Request for Tender EP 101- 2020

ADDENDUM #4

Chiller Replacement at Enercare Centre

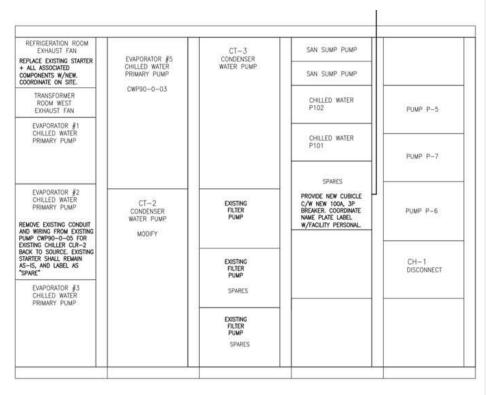
- Q1. can you confirm if the riggers and machinery movers workforce must be unionized workers pursuant to Exhibition Place's "Labour Trades Contractual Obligations in the Construction Industry", the spec isn't entirely clear on the matter.
- A1. Refer to Workers' right in the tender package under Schedule F
- Q2 Are we to only supply/install a starter for the refrigerant room exhaust fan, or is the actual fan or motor to be replaced as well?
- A2. Replace existing 10 HP starter only in existing MCC-5.
- Q3. RFI#1 Please provide HP information on Refrigeration Rm Exhaust Fan Starter 1 – Refrigeration Rm Exhaust Fan Starter in MCC-5 (Will Confirm Size) – what size?
- A3. See Detail 10 & 11/M14 Attached

Also Refer to response on A3 above and refer to ADDENDUM No 1 Q11 and response A11. Existing exhaust fan has a 10 HP.
